SUBJECT 30 Simkm. Report referenced as SP/01/212

CONSTRUCTION REVIEW CERTIFICATE

Issued by: Graeme Purdie - Building Surveyor
to: Melisa Wilkey
in respect of: Unauthorised Decks at - 30 Simkin Ave, St. Johns

UNAUTHORISED BUILDING WORK: 30 (UNITS 2 & 3) SIMKIN AVENUE, ST JOHNS

UNAUTHORISED DECKS		DRAWING No	DRAWN BY
30 SIMKIN AVE, ST JOHNS AUCKLAND		MW -01	G PURDIE
JUNE 2001

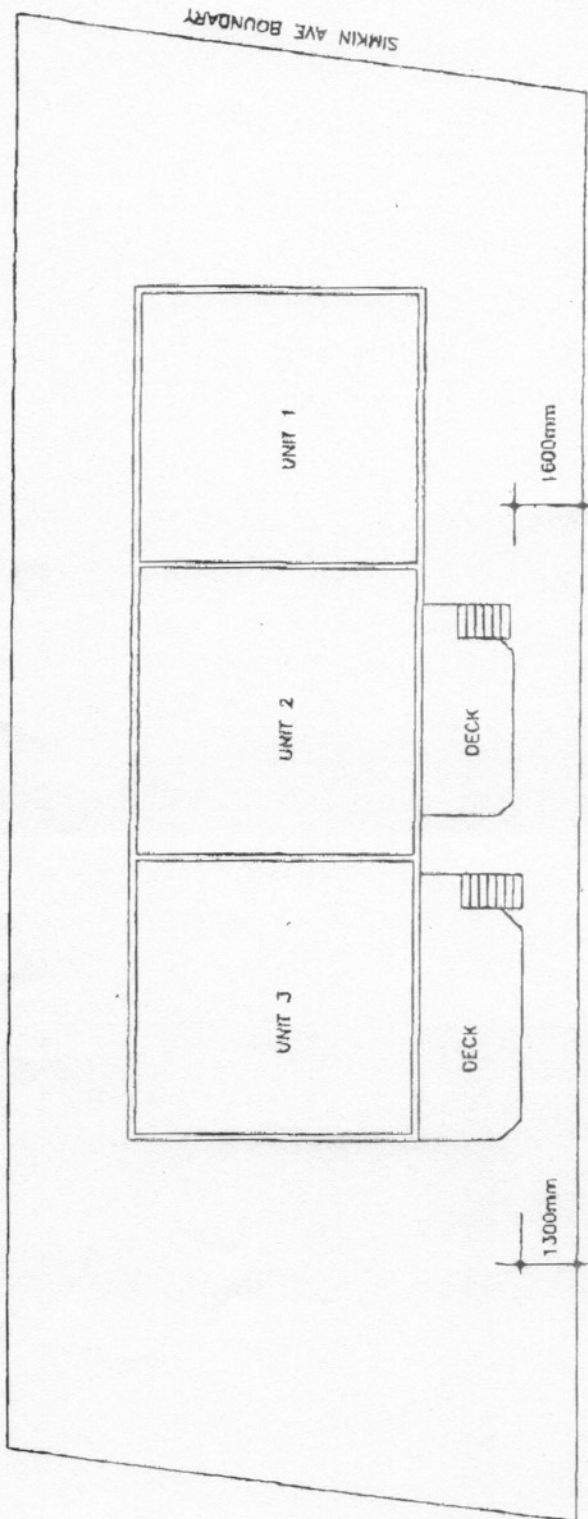
The timber decks and steps attached to the north elevation of units 2 & 3 at the above address, have been constructed accordance with the requirements of NZS 3604:1990, apart from the handrail, which must be raised to 1000mm above the deck. as indicated in the attached drawing.

The Building Act 1991 does not make provision for the issue of building consents after work has been completed, therefore the council must consider the above work as illegal. However, as the structure was both safe and sanitary on the date of inspection. Therefore, I believe Section 8 of the Building Act¹ applies with no further remedial work required apart from - raising the handrail is as indicated in the attached drawing.

RAISE EXISTING HANDRAIL
Scale 1:10

✓ DONE
01/07/01

30 SIMKIN AVE
ST JOHNS
1 JULY 2001

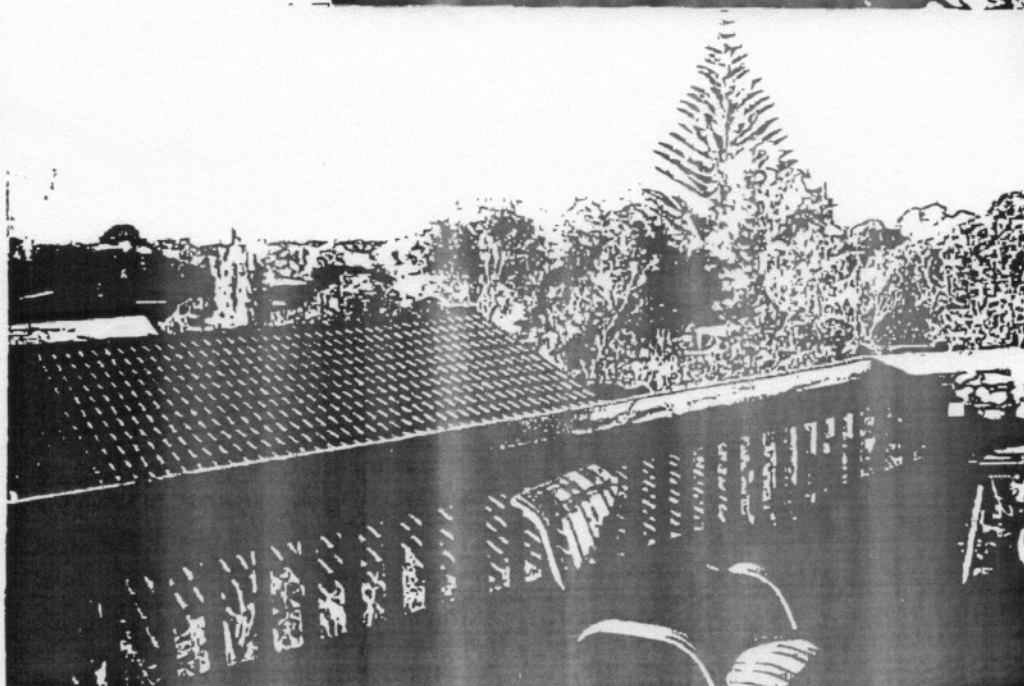
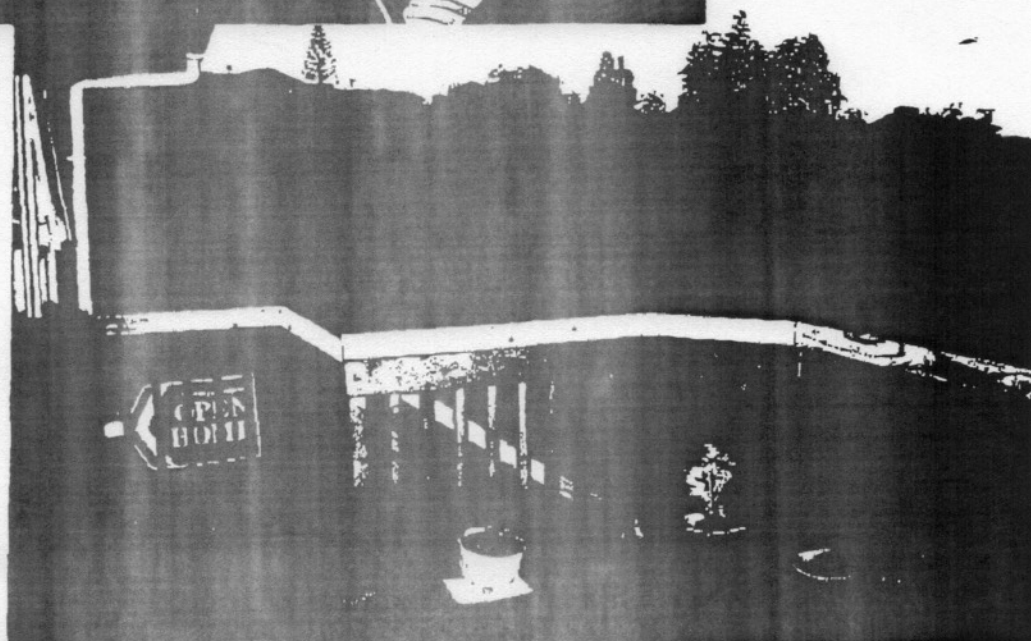
Work completed
1 July 2001
See attached
photographs.
SIGNED: MELISA WILKEY: M.Wilkey 217101
